**CITY OF BLOOMINGTON**

**CITY OF BLOOMINGTON  
PLAN COMMISSION AGENDA  
Nov. 5, 2012 @ 5:30 p.m.**

**BLOOMINGTON PLAN COMMISSION  
STAFF REPORT  
Location: 601 N. Walnut Street**

**BLOOMINGTON PLAN COMMISSION  
STAFF REPORT  
LOCATION: 3020 E. 3<sup>rd</sup> Street**

1 WALNUT STREET ELEVATION  
3/32" = 1'-0"

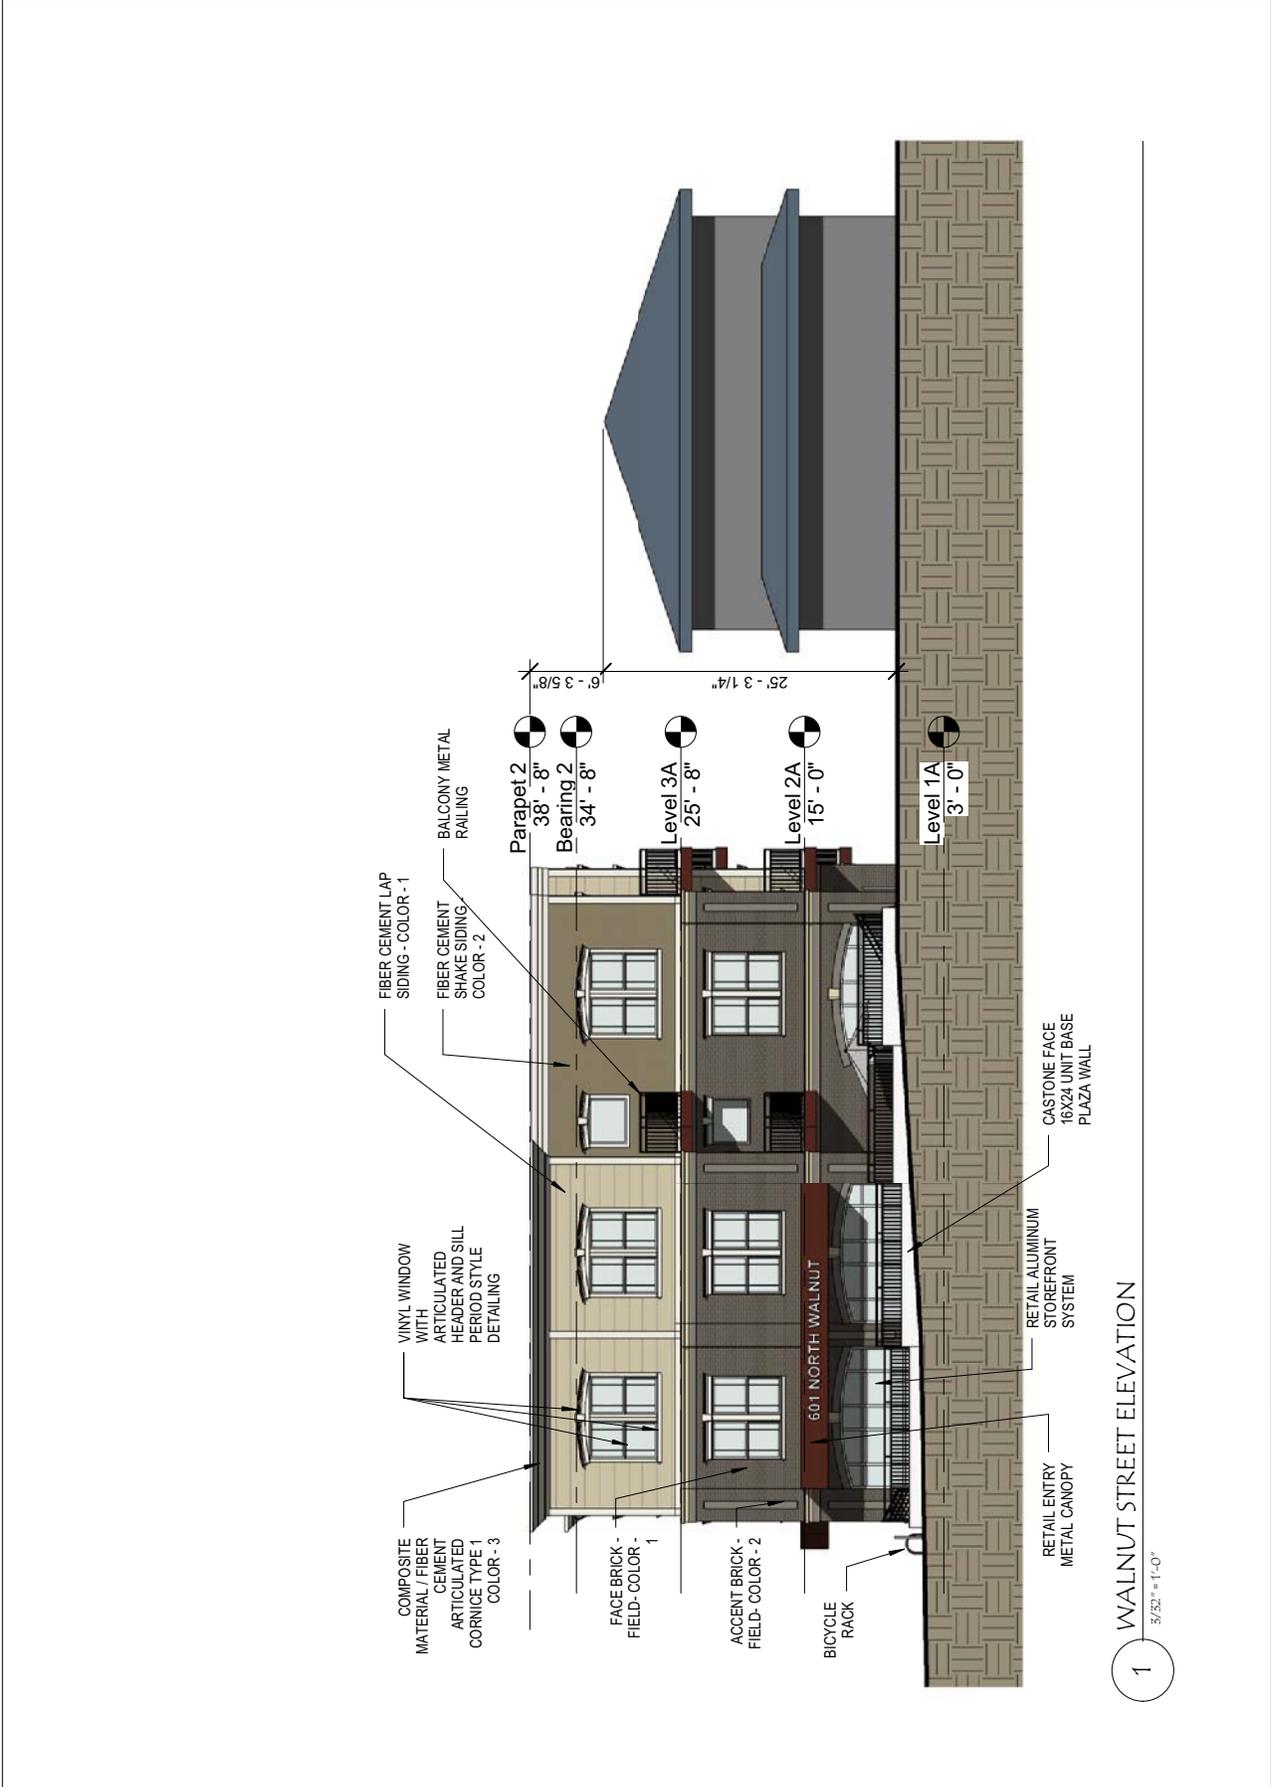
**Height:** The building is a 3-story structure, with rooftop architectural elements and an elevator tower increasing the height. There is approximately 10 feet of grade change along the street frontage of the property, with the low point being at the southwest corner and the high point at the northeast corner. When measured along the grade, the majority of the building mass is 35'8", with the height increasing to 38'8" at the corner and along Walnut St. The DGO has a maximum height of 40 feet.

**Building Height Step Back Waiver-20.03.340(c)(3):** A waiver from the minimum stepback height architectural standard of the DGO is required to allow portions of the building to be as tall as 38'8" feet without a step back. The DGO requires that buildings taller than 35' be stepped back from the street at a height of 25 feet. Guideline 3.9 of the Downtown Plan recommends that new buildings "maintain the perceived building scale of two to four stories in height." It goes on to state that "if a building must be taller, consider stepping upper stories back from the main façade." The Downtown Plan does not give a recommended height for the step back, but instead recommends step backs for buildings over 4 stories. The proposed building is 3 stories tall. The additional height is necessary due to the change in grade on the property, the proposed parapet, and the elevator riser.

- 1.) The new building should match the street setback of the historic structure. The proposed building has two masses along Walnut St. The mass closest to the intersection aligns with the historic structure's front porch, while the northern mass aligns with the main mass of the historic structure.
- 2.) The new building should be no taller than 14 feet or 1-story, whichever is less, in comparison to the historic structure. The revised proposal is less than 6.5 feet taller than the historic structure at the street.

Site Plan  
PUD-37-12

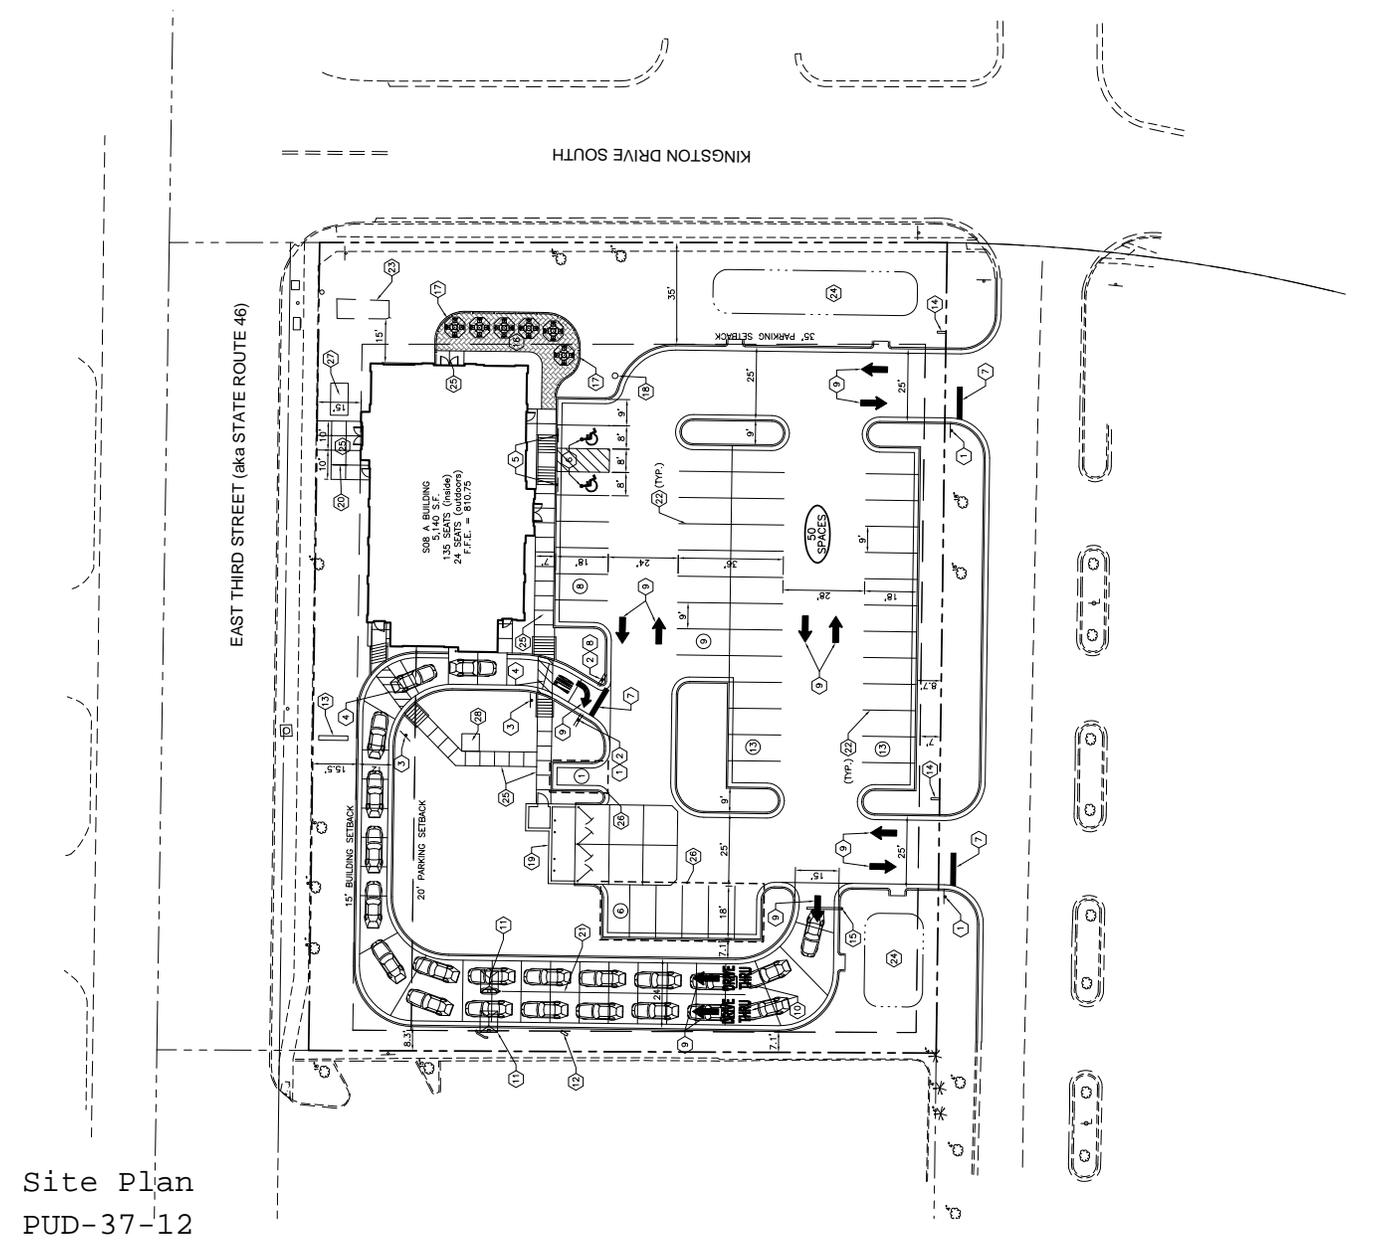
**Tree Preservation/Landscaping:** Several species proposed will need to be replaced with species that meet the requirements of the UDO. The landscaping plan will be fully compliant prior to permitting. Several existing trees will be preserved with this proposal.

**Architecture:** The proposed one-story building has an overall height of 25.5 feet. The petitioner has included large storefront windows on the south and east sides of the building. Color elevations have been provided. The amount of window space that can be provided along E. 3<sup>rd</sup> St. is constrained by functional wall space in the kitchen, office, and mechanical areas. The petitioner has worked with staff to provide a window along E. 3<sup>rd</sup> Street into the play area, and the proposed transom windows will be clear glass. The petitioner is proposing canopies, façade and height modulations, and several colors of brick to provide architectural variation and interest. There will be entrances into the building from both E. 3<sup>rd</sup> St. and from the parking lot to the south.
